Different Problems faced and Changes Implemented for Powerhouse Cavern

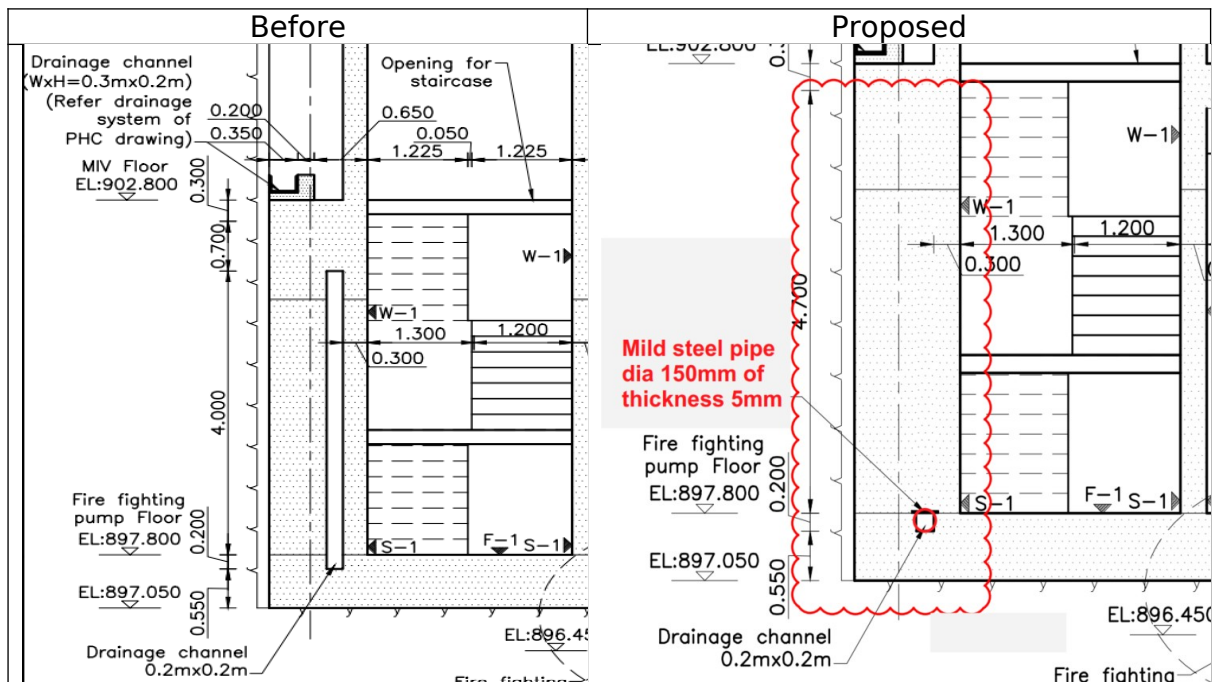
1. DCN-24-C-001: Date 01 Jan 2024, due to the Construction Teams requirement i.e. difficulty in formwork execution behind the Shear Wall of Staircase of Bay 01 Draft Tube Floor, the 20cm gap was decided to fill with concrete. The Drainage Trench was also decided to be replaced by Mild-Steel Pipe of Dia 150mm.

| Previous revision | Updaetd |

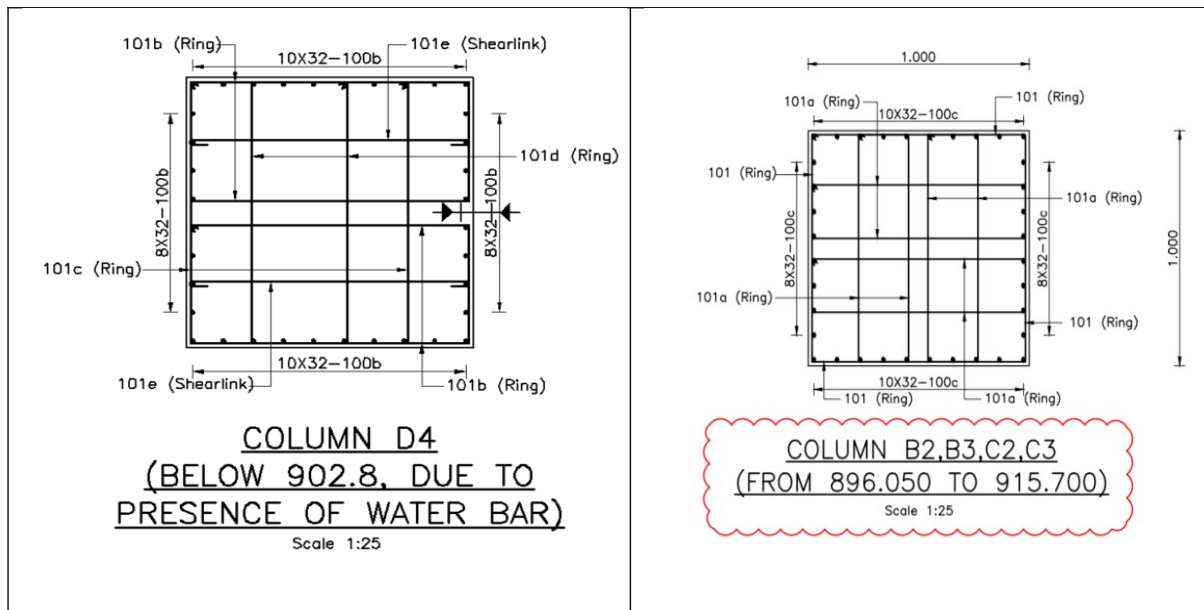
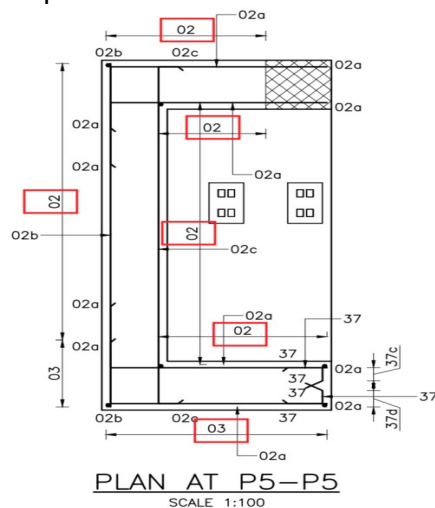
2. Before, it was planned to install the WaterStop at the Column D4 of Bay 01 and Column D5 of Bay 02, but after it was recommended no necessity of Waterstop at those area by Doosan Team Member. So Waterstop was removed from the drawing of both Bay 01 and Bay 02 of respective column and was also not installed at site.

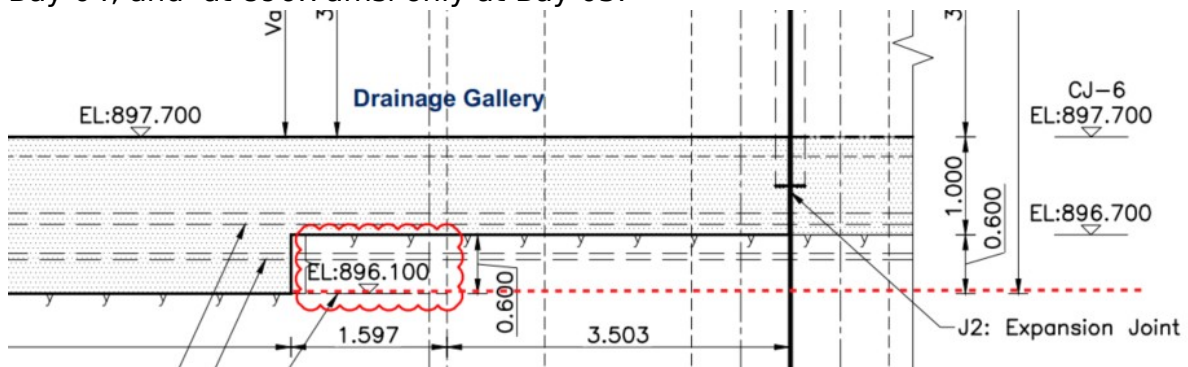
3. Bay 02, Reinforcement Drawing Below 902.8amsl Rev.0C: In the Drainage Slump, Rebar 02 and 03 (Vertical Wall rebars) were submitted with development with 300mm. The BBS had already been implemented at site. But in the revised drawing from Sanima for same Rev.0C (with no revision cloud mark), same rebars were given 1250mm development in BBS which gave the problem at site. As OE people had the new revised drawing, Rebar 02 and 03 had to be replaced as per new BBs i.e. 1250 Development Length.

Also, 1m width wall on the face of Drainage gallery of Bay 02 had no closing rebar in the previous Drawing provided by Sanima. In the revised drawing, this mistake was also corrected and was implemented at site.
